F6 Extension Stage 1

New M5 Motorway at Arncliffe to
President Avenue at Kogarah

Submissions report

Figure A2-1 Water features in the southern part of the project

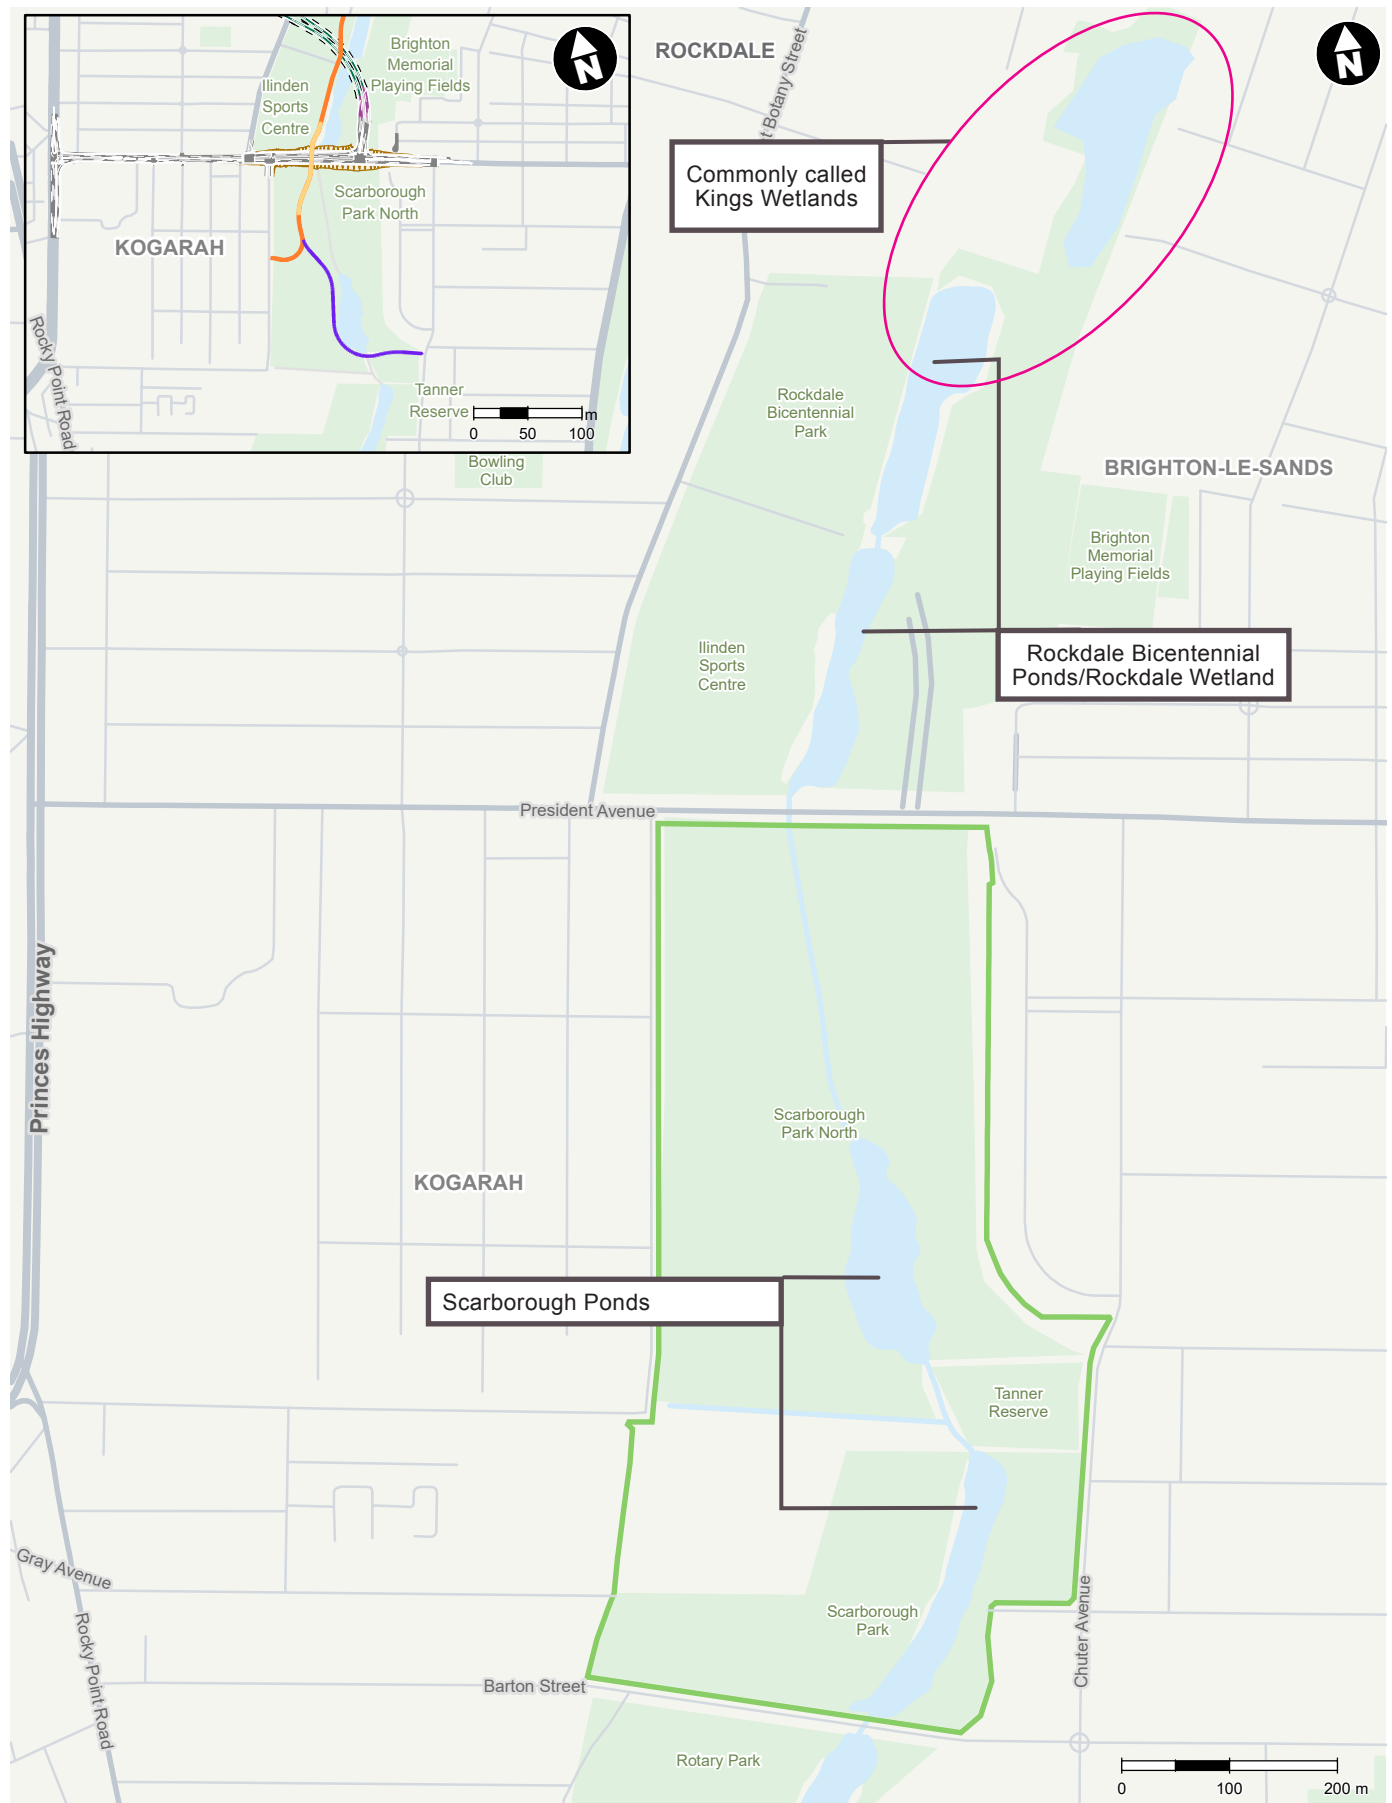
The area to the south of President Avenue is known as Scarborough Park North and includes waterways referred to as the Scarborough Ponds.

Scarborough Park North is also referred to as Patmore Swamp. The name 'Patmore Swamp' is the name of the heritage listing for part of this area under the Rockdale Local Environmental Plan 2011 (item number 202).

Figure A2-1 has been produced to clarify these different water features and nomenclature.

Figure B-3 Hourly mean NO₂/NO_x and NO_x at F6 Extension Stage 1 stations (December 2017 to December 2018)

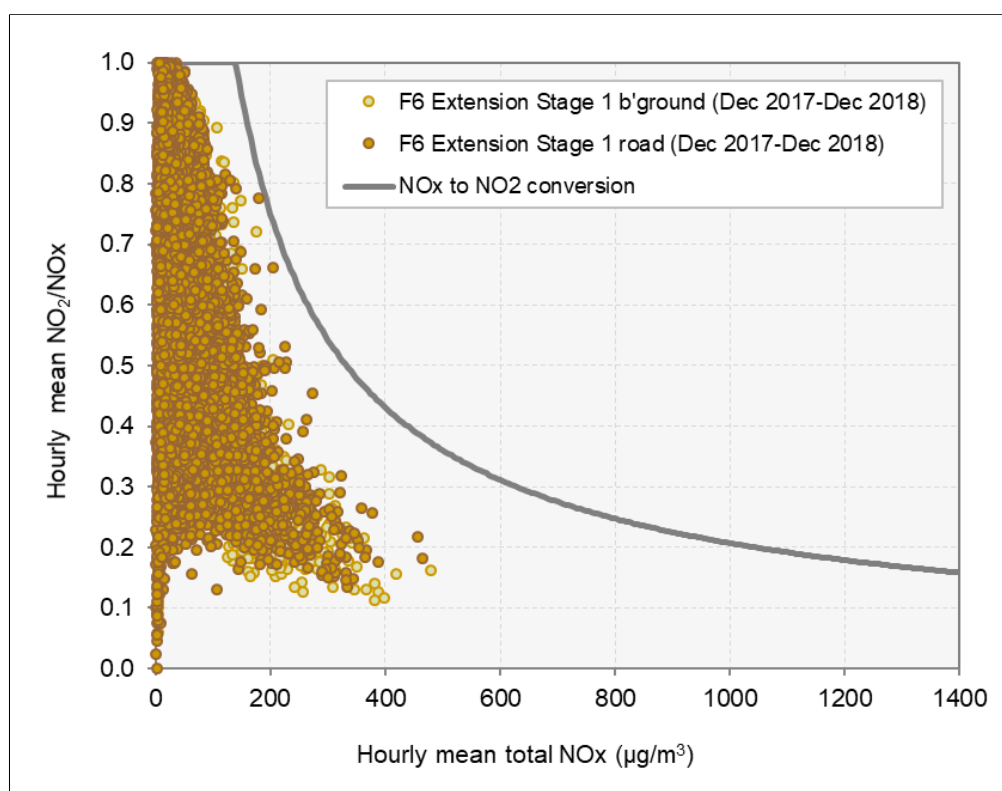
The EPA notes that Annexure H includes a model evaluation, however the model evaluation has not been conducted for the project specific monitoring locations. The EPA considers that the evaluation with project specific monitoring data should be included despite the noted difference in the time periods covered by the site-specific data. Annexure E of the Air Quality Technical Report provides the analysis conducted for the derivation of the empirical formula for NO_x-to NO₂ conversion. TA-Air notes that Figure E-7 includes project specific monitoring data collected for the two project specific stations. However, a comparison of the empirical approach with the site-specific data does not appear to be included. The EPA considers that a comparison of project specific data with the NO₂/NO_x function adopted for the project assessment should be included.

Project specific monitoring be compared against the NO₂/NO_x function adopted for the project

At the time of the air quality study for the EIS, data from the two project-specific monitoring stations (one background, one roadside) were only available for the period between December 2017 and June 2018. Data is now available up to December 2018. For the two F6 Extension monitoring stations, **Figure B-3** shows the hourly mean NO_x and NO₂/NO_x data for the full period. It can be seen that all the measurements from the F6 Extension monitoring stations were inside the envelope of the conversion function that was used in the air quality assessment, and this reflects the conservative nature of the NO₂ assessment for the specific area of the project.
